## CALIFORNIA COASTAL COMMISSION

AMENDMENT REQUEST  
STAFF REPORT AND PRELIMINARY RECOMMENDATION

Application No.: A-6-OCN-99-133-A1

Amendment: Request for after the fact approval of a vinyl fence, two gates and a block wall, all 6-feet high; the portion of the fence that extends to the revetment is proposed to be reduced to 3-feet high.

EXHIBIT NO. 3a-c  
APPLICATION NO.  
A-6-OCN-99-133-A1  
Fence to Revetment

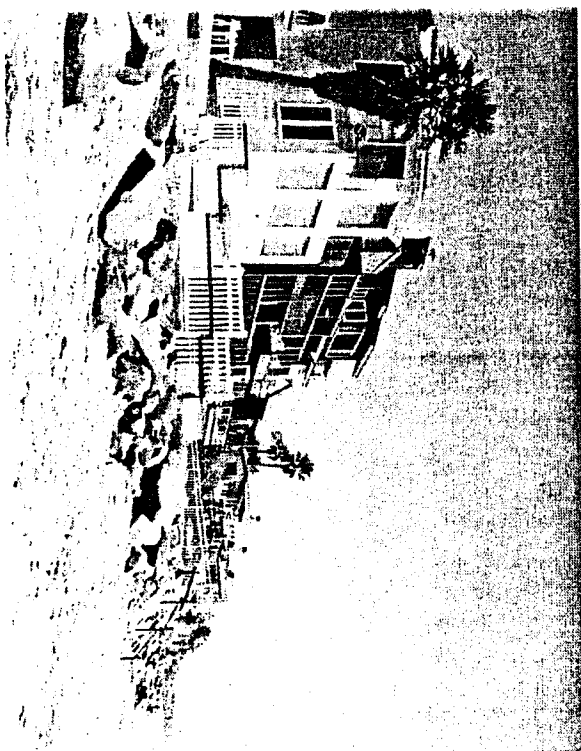
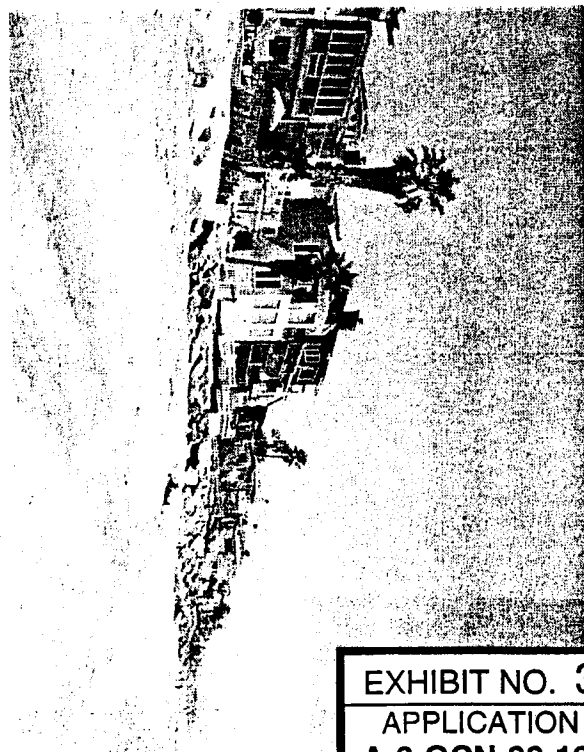
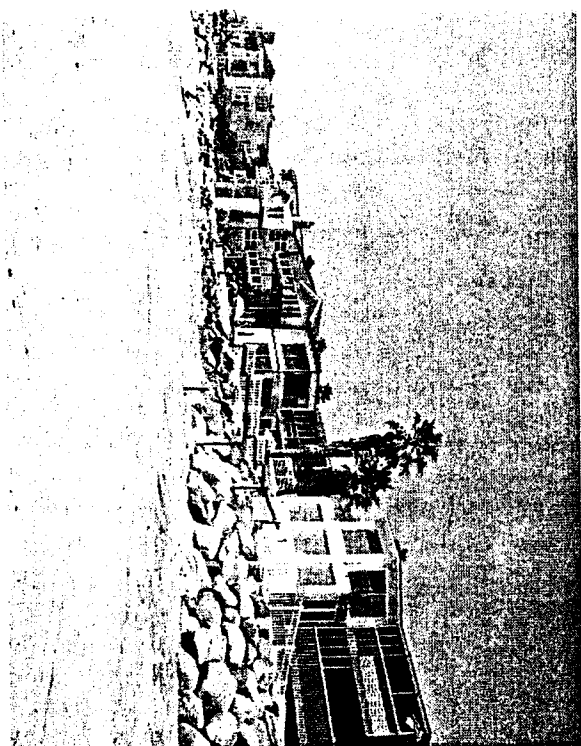
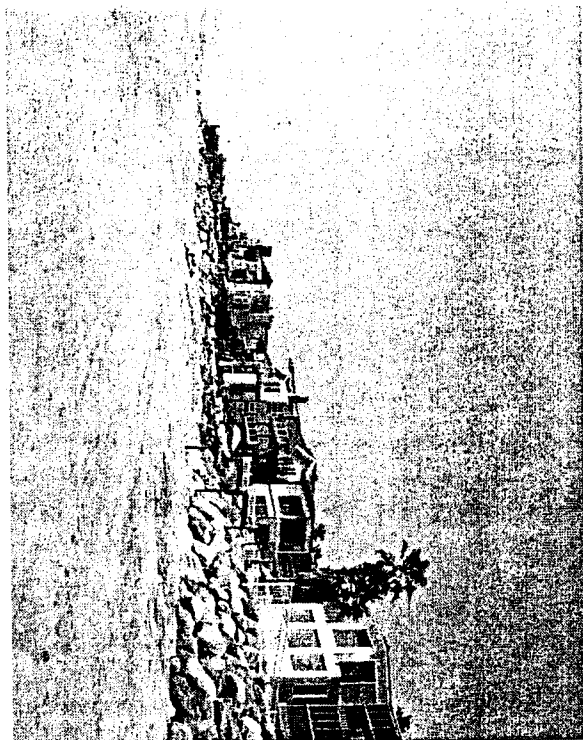
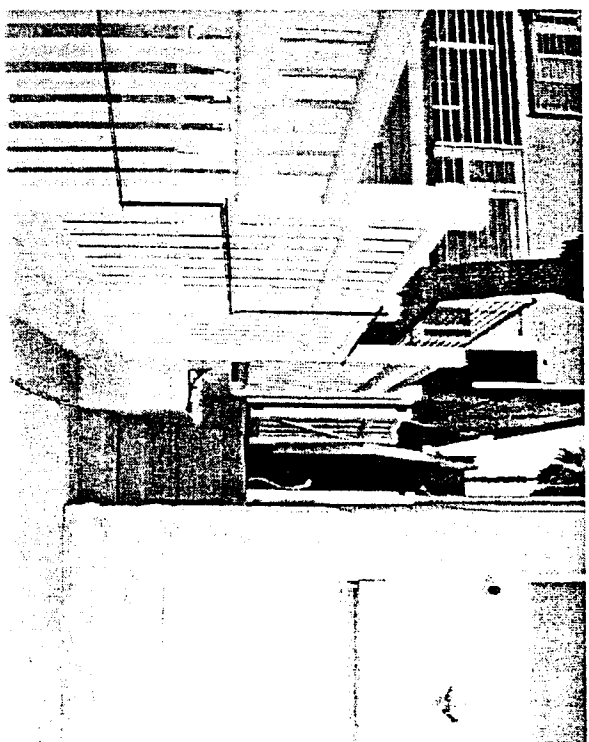
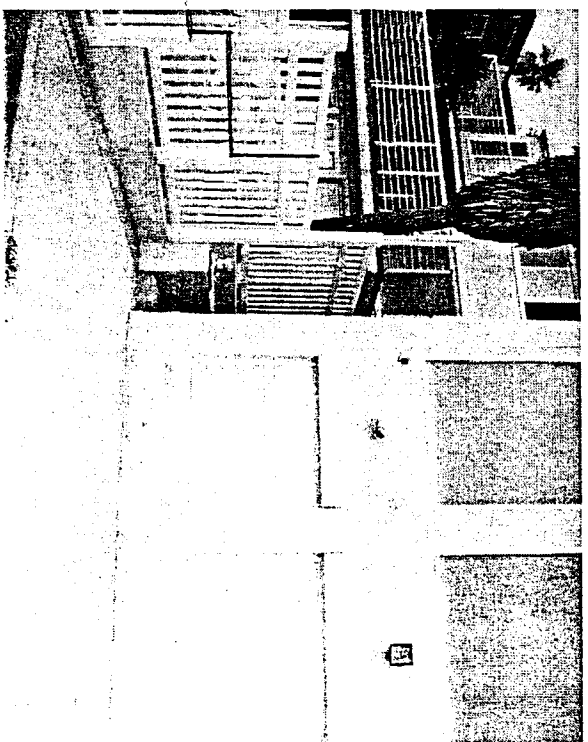
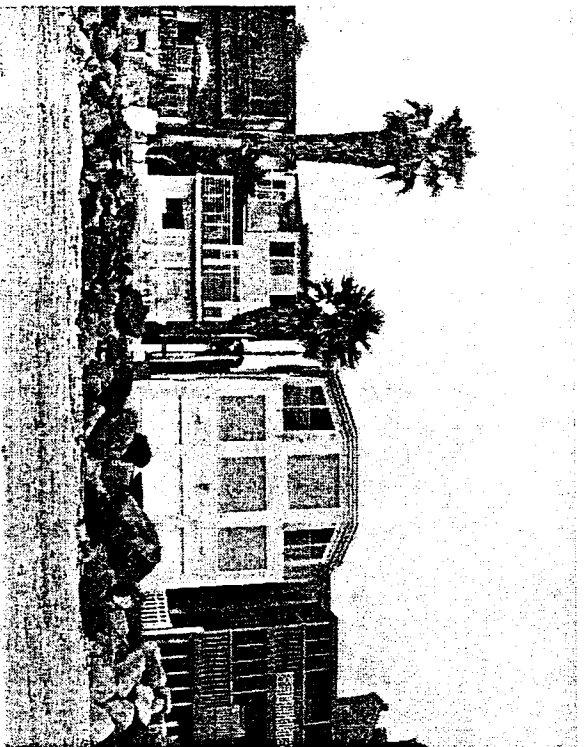
In this case, a recently constructed, but unpermitted 6-foot high vinyl fence exists near the northwest corner of the home and extends west towards the ocean approximately 36 lineal feet to the top of the revetment. The stringline coincides with the seaward edge of the home; therefore, the fence extends approximately 36 ft. seaward of the stringline. As noted above, Section 1703 allows structures such as open decks, patios and balconies seaward of the stringline; however, the ordinance does not identify fences as permitted

Additionally, even if the fence were a permitted use, it has an adverse impact on public views which are protected in the LCP. The Commission has previously found in this area that public views from the beach and vertical access ways are important and must be preserved based on the visual resource policies of the LCP. Down coast public views (to the south) from Whaley Street are adversely affected by the fence because the beach is significantly lower than the fence resulting in the fence being elevated into the public view. The proposed fence would also have an adverse impact on up coast public views (to the north) from the Cassidy Street stairway (south of the site) were it not for the existence of a similar fence which exists on the adjacent lot to the south. This adjacent fence has an adverse visual impact and there is no record that it is permitted. If and when it is removed as a violation of the Coastal Act, the subject fence would have an adverse impact on views northward from Cassidy Street as well.

6' Block Wall →

6' Fence to  
Revetment  
(Proposed at  
3' high) →

6' Gate ←

As discussed above, the proposed gates, fence and wall are inconsistent with the height standard in the LCP and the fence beyond the stringline is not permitted by the certified LCP. While the fence is proposed to be lowered to 3-feet high beyond the stringline, the LCP does not allow encroachment of fences seaward of the stringline. The LCP regulates development this way to protect public and private views along the shoreline. Therefore, the Commission finds that the proposed development is inconsistent with the visual resource policies of the certified Oceanside LCP and must be denied.

NORTH SIDNEYARD FENCE 1731 S. PACIFIC

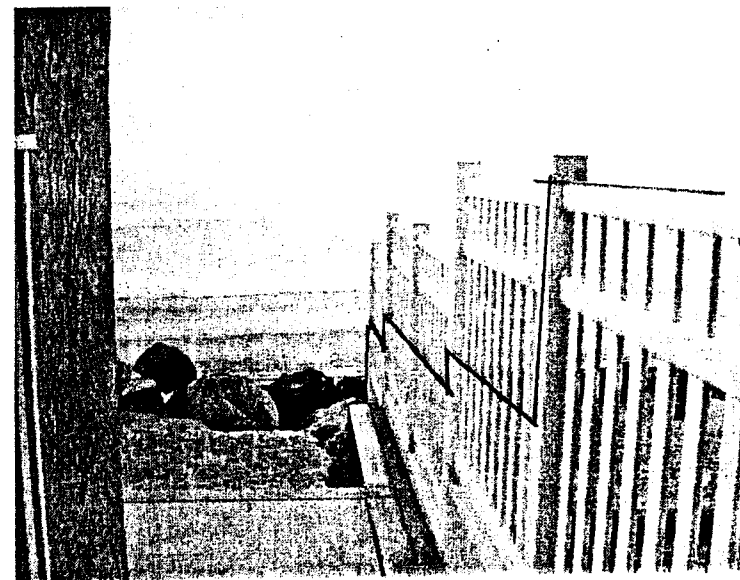
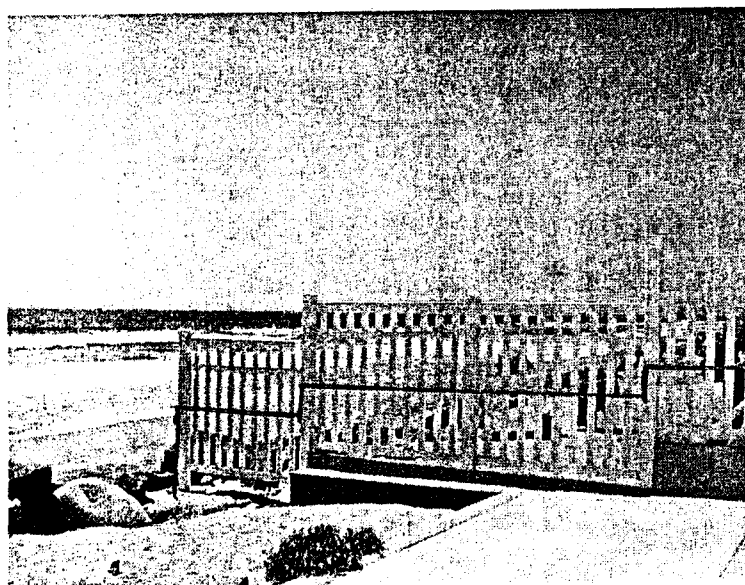
PROPOSED CHANGE

NO PROPOSED CHANGE TO EXIST. MASONRY WALL

PROPOSED CHANGE
